SUBJECT: Enforcement Petition (10 CFR §2.206) Regarding Exelon's Byron and Braidwood Stations

Samuel Miranda (the Petitioner) hereby submits this Petition, pursuant to the terms of 10 CFR §2.206, regarding the licensing and operation of the Byron and Braidwood Stations. Specifically, the Licensee (Commonwealth Edison; which was succeeded by Exelon) has obtained the NRC's authorization to operate its Byron and Braidwood Stations at uprated power levels, based upon evaluations of certain anticipated operational occurrences (AOOs) that are rife with errors, and omissions. More importantly, the Licensee employed a circular logic that failed to demonstrate that the Byron and Braidwood plant design meets all of its design requirements. Hence, this petition for enforcement.

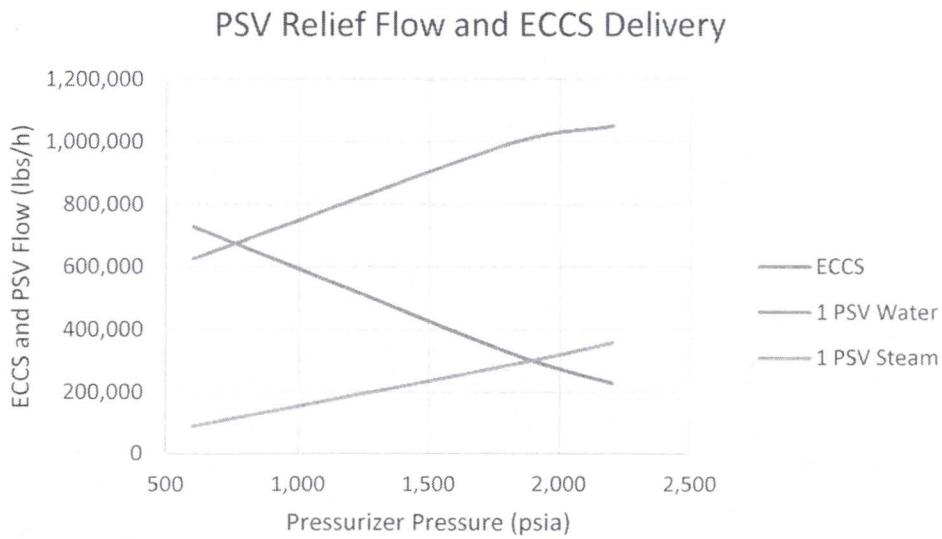
The situation that the Licensee describes, wherein the flow through the open PSV would be matched by the flow that is delivered by the ECCS flow, would be true only after RCS pressure has dropped to very low levels, late in the IOECCS scenario; long after the non-escalation requirement has been violated. At high RCS pressures, the critical (choked) water flow, through the PSV, will be much greater than the ECCS flow that is delivered. Here is an illustration of this relationship for one PSV. This is a conservative depiction, since (1) ECCS flow is high (i.e., the maximum ECCS flow rate is represented), and (2) the PSV relief rate is low (i.e., there could be as many as three stuck open PSVs). At worst, as many as three PSVs could stick open, and create a hole that is equivalent to a 3.7 inch hot leg LOCA.

The figure shows that ECCS flow rate will not exceed the PSV water relief rate until the RCS pressure approaches the accumulator injection setpoint (about 600 psia).

{Error 4} The Licensee claims that ECCS flow will match PSV water relief rate.
